Sublime Greentex Ltd. Executive Intimates Ltd.

Gilarchala, Sreepur, Gazipur
(24.194254, 90.425146)
25th February 2018

Observations

Layout Plan

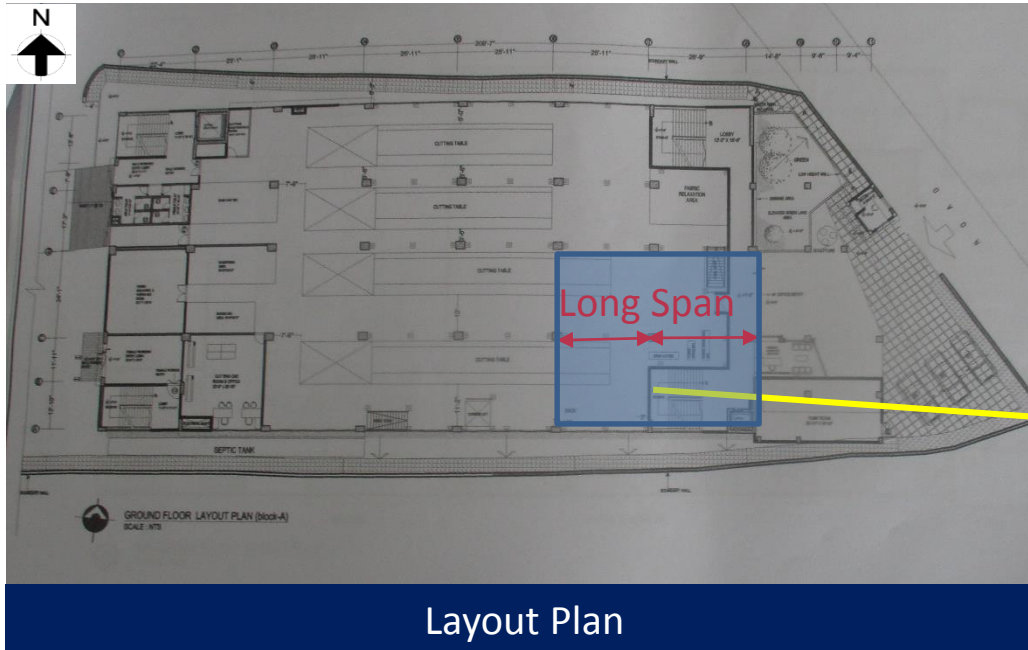
Column to be stressed above normal design limits

Cursory calculations indicate that the working stress of the columns at Ground Floor level are above normal design limits.

Column Schedule

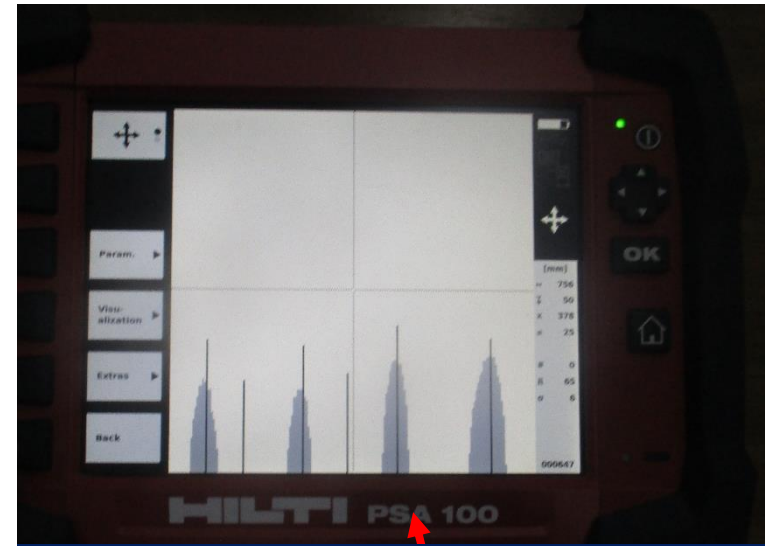
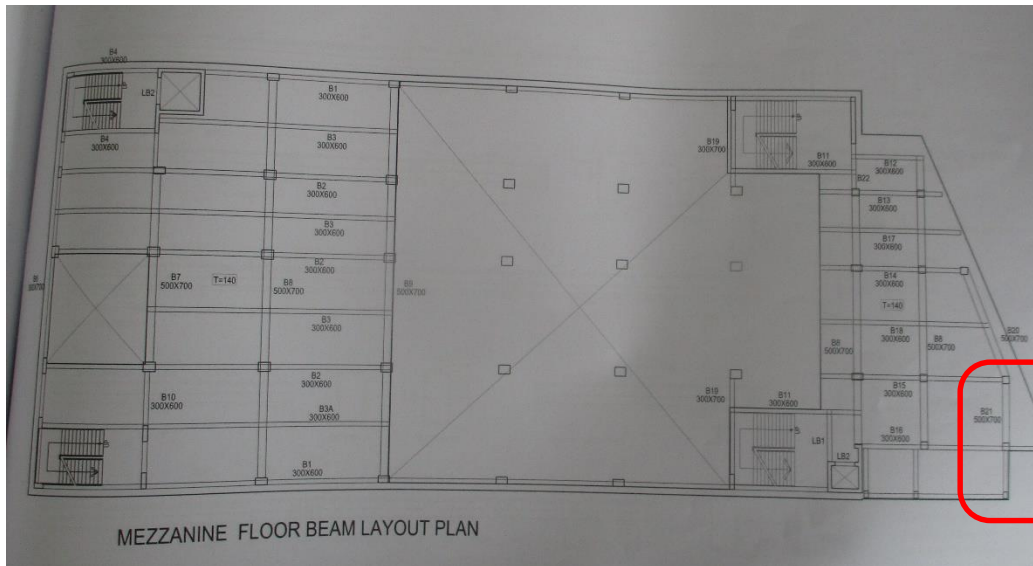
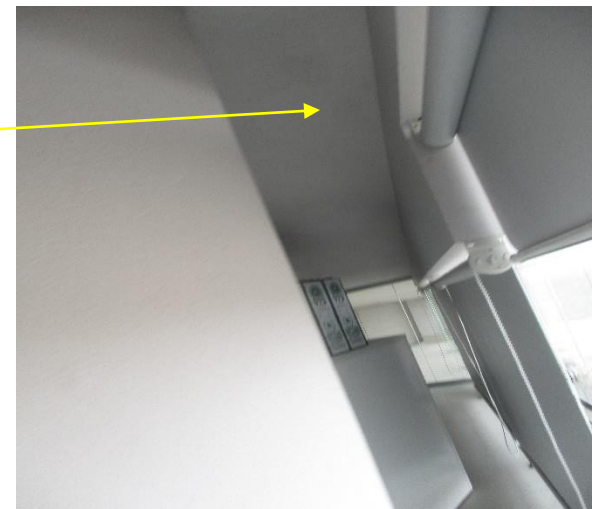
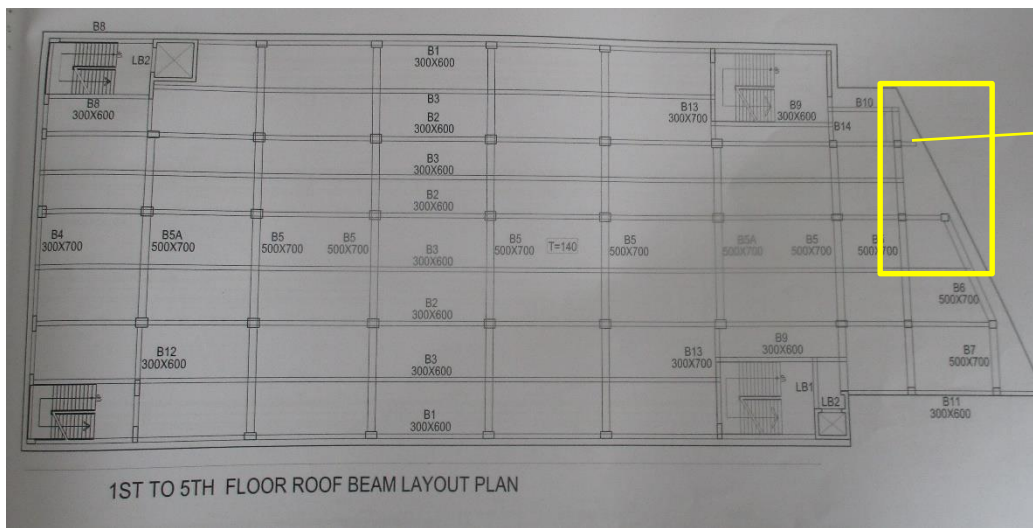
Discrepancy between provided drawing and on-site condition

Observed by ferro scan at 3rd Floor

14 rebars (6 rebars on long face)

Reinforcement detected by Ferro Scanning internal and external columns in Production Building appears to be different than shown in the structural drawings.

Building engineer to verify number and diameter of rebars at least at two sides by removing plaster and concrete cover of typical columns.

Large floor cantilevers at East

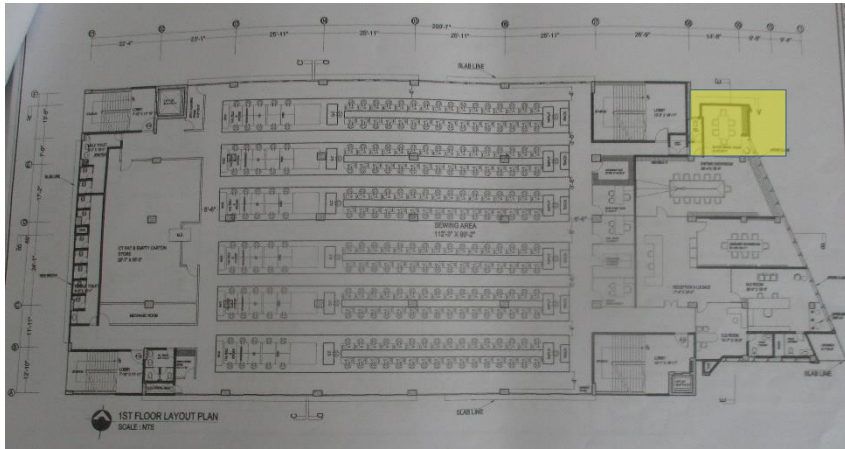
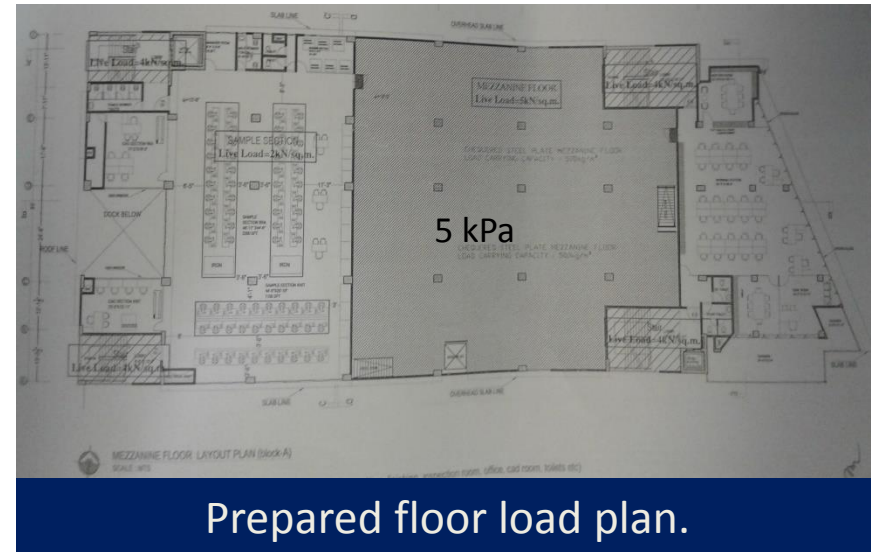
Beam layout does not match with as built condition. Cantilever beams at front are not shown properly on drawings.

Large cantilever beam was observed at the front side of the building. Building Engineer to check structural adequacy of the cantilever and propose any remedial actions if required.

Columns susceptible to vehicle impact

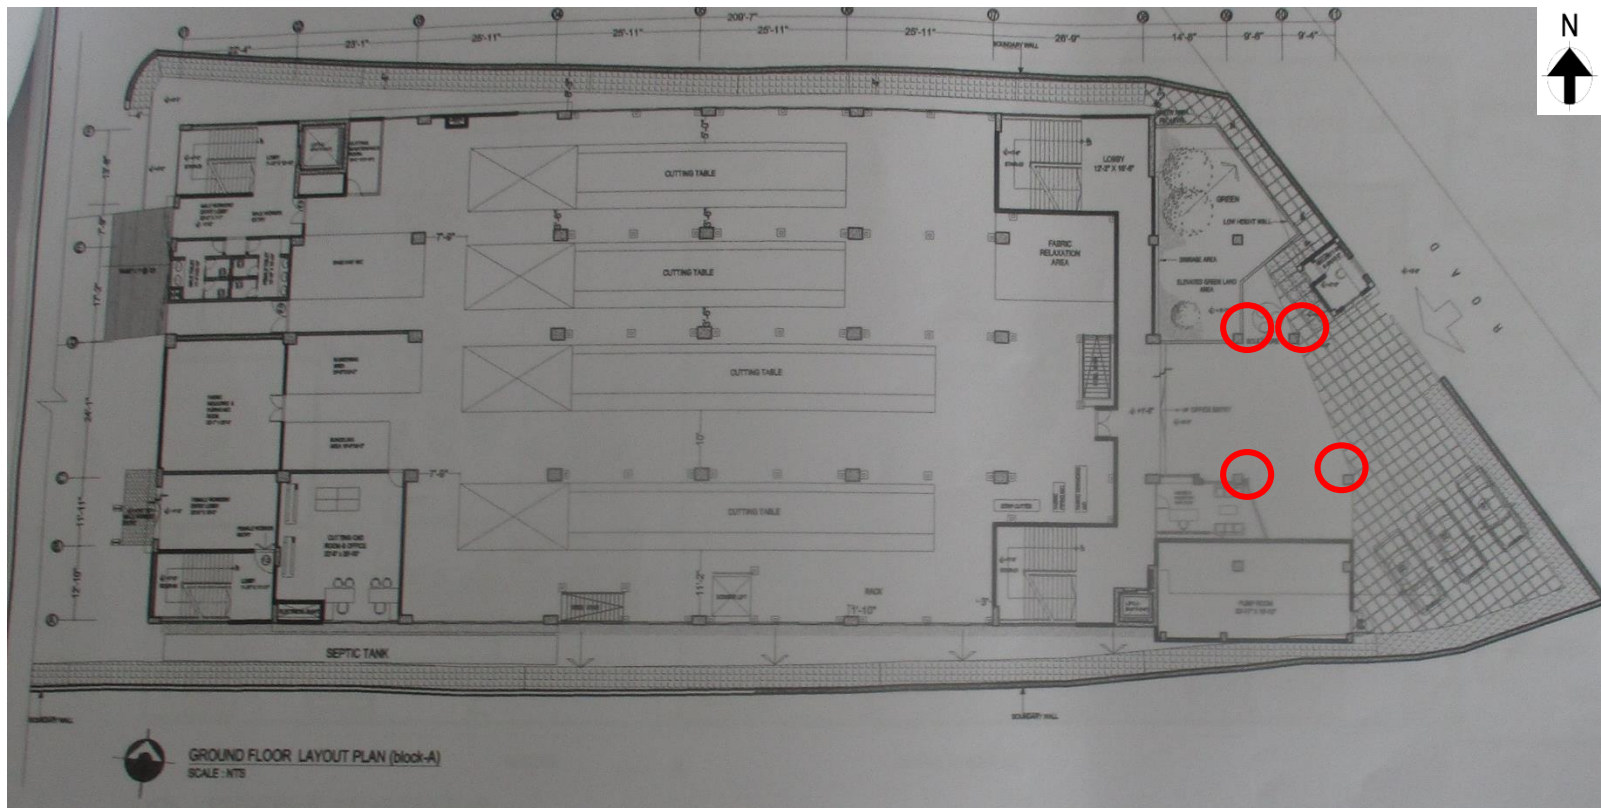
Impact protections are not provided to the columns at front parking area. Columns are susceptible to impact loading from vehicles.

Discrepancy between provided drawing and on-site condition

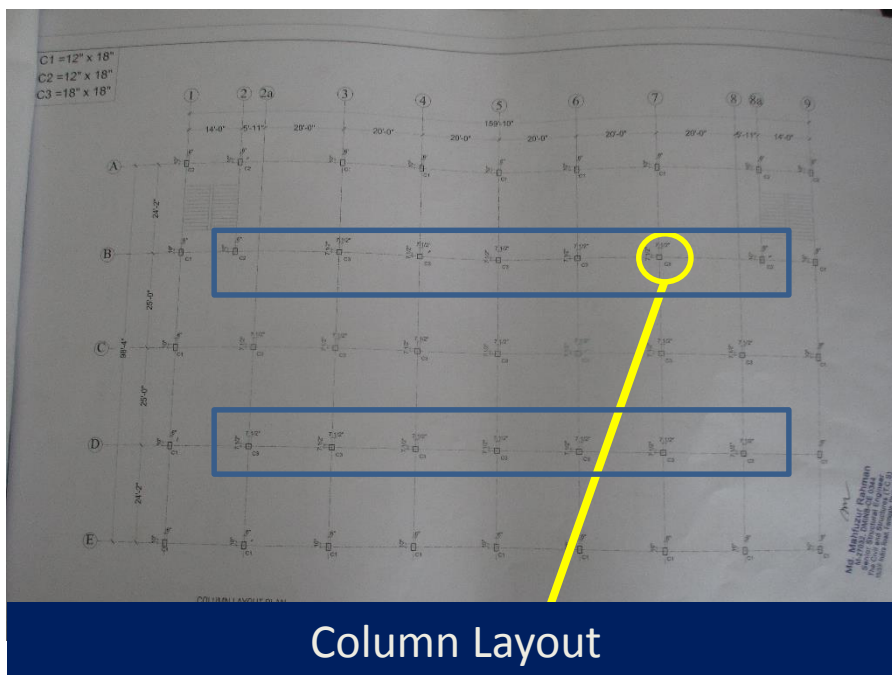
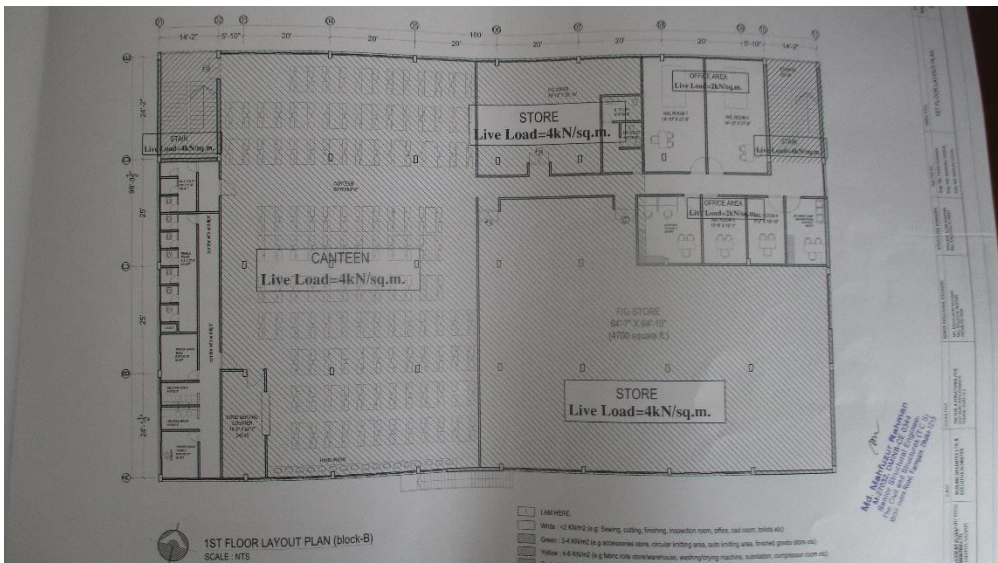
375 mm instead of 450 mm

C-3 type column section was found (375 X 375 mm) instead of (450mmX450mm) along grid B & D. Building engineer to verify sizes of each column and prepare accurate as-built drawings.
